LR-N07-0099
LCR H05-01, Rev. 1
April 30, 2007

Hope Creek Generating Station
Facility Operating License No. NPF-57
NRC Docket No. 50-354

Subject: Response to Request for Additional Information
Request for License Amendment - Extended Power Uprate

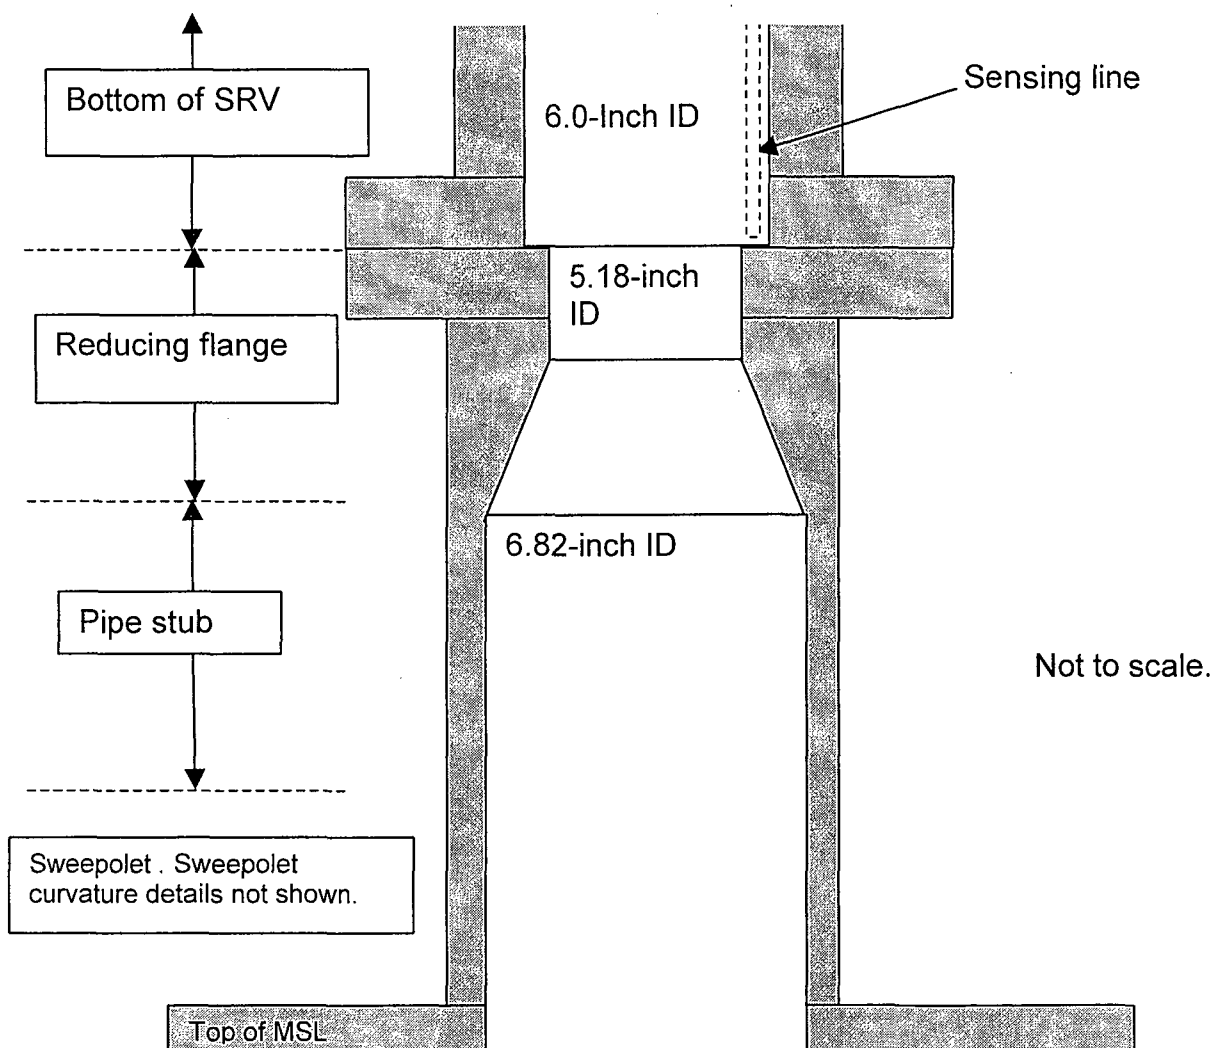
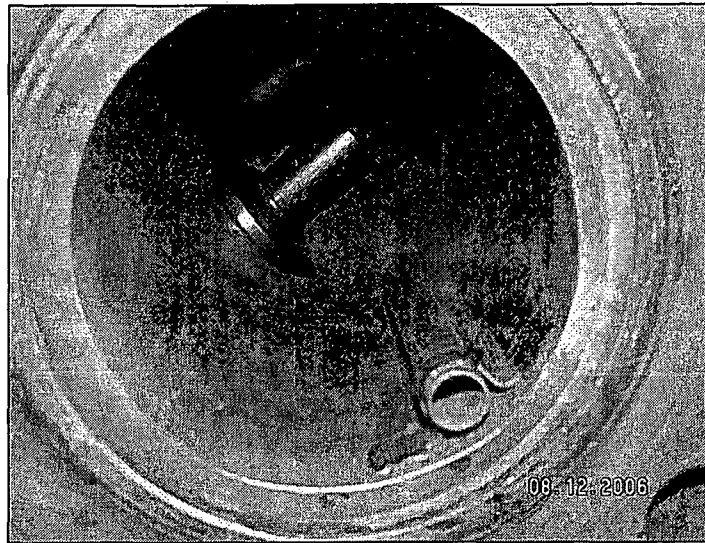
- 14.19 In reference to Attachment 22 of the Hope Creek EPU submittal, demonstrate that the safety relief valves will operate properly at EPU conditions. PSEG's response to this request should include the assessment of (a) the acoustic - pressure in the standpipes at EPU conditions, and (b) the effect of acoustic pressure at EPU on the structural integrity of the SRVs.

HCGS reviewed the acoustic resonance concern and its potential impact on valve operability as a result of the failures at Quad Cities. Quad Cities had several relief valve designs including several Target Rock valves that were subject to very high acoustic resonance in the MSLs prior to the mitigation efforts taken in early 2006. The valves that failed were not the Target Rock valves. The failure on a non-Target Rock valve was due to excess wear on valve components that was directly attributable to the high vibration.

The photo is taken from the bottom of a Target Rock 7567F looking upward. The tube inside is the sensing line that leads to the seat of the valve's pilot operator. The other valve components exposed to the valve chamber are major components that are not considered susceptible to the pressure pulsations from acoustic resonance.

As illustrated in the sketch, the sensing line opening is just above the interface between the upper and lower halves of the flanges. The opening is approximately halfway up the overall chamber. The smaller ID of the lower flange half is intended to shield the sensing lines from flow induced phenomena when

RAI 14.39 Figure 1. Main Steam Line A Accelerometer Locations – Drywell

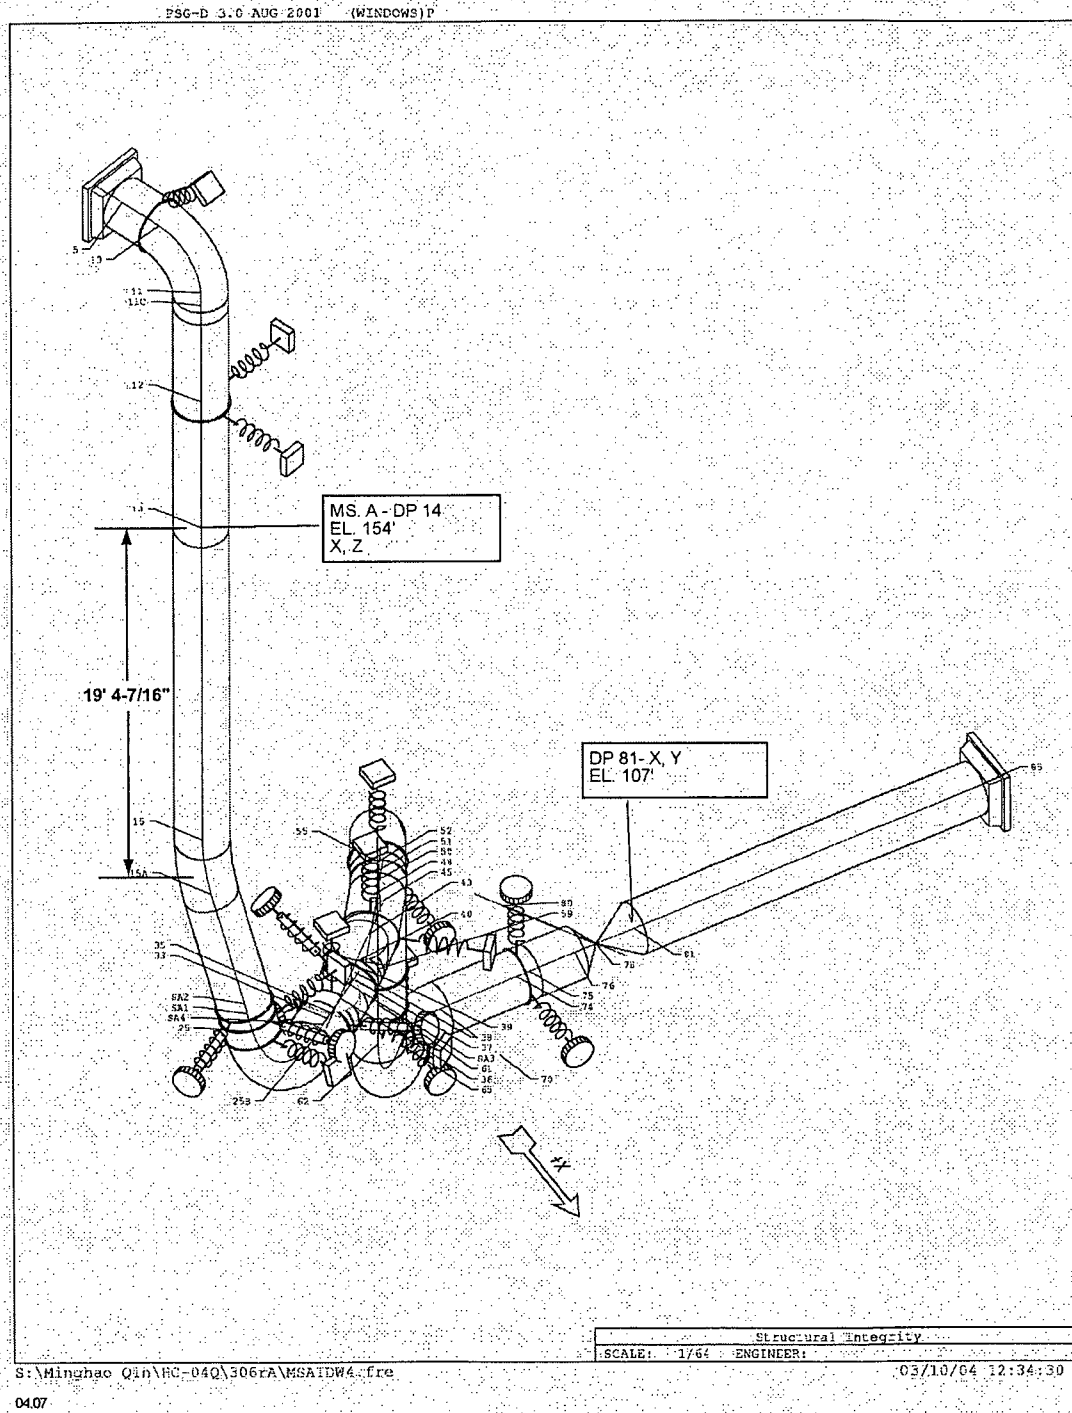
- 14.39 In reference to Attachment 8 of the Hope Creek EPU submittal, provide (a) applicable types of accelerometers/instruments for each of Vibration Monitoring Groups, and (b) locations of instruments and technical basis for selection of the monitoring locations.

As described in attachment 8, the instrumentation for VMG 1 consists of accelerometers. The accelerometer locations on this piping were selected based on detailed analyses of the piping, which identifies the resonance frequencies for the piping, correlates vibration levels to flow induced vibration (FIV) stress levels, and establishes the maximum allowed vibration (i.e., acceptance criteria). To determine the accelerometer locations, models of the piping were created, using PIPESTRESS which represents the dynamic characteristics of each monitored line. To provide the maximum number of natural frequencies with the minimum number of instruments, modal analyses of the piping systems were performed.

PSEG will add accelerometers on four (4) Safety Relief Valves (SRVs) (two SRVs on main steam lines "A" and 2 SRVs on MSL "B") to monitor acceptable vibration levels during power ascension.
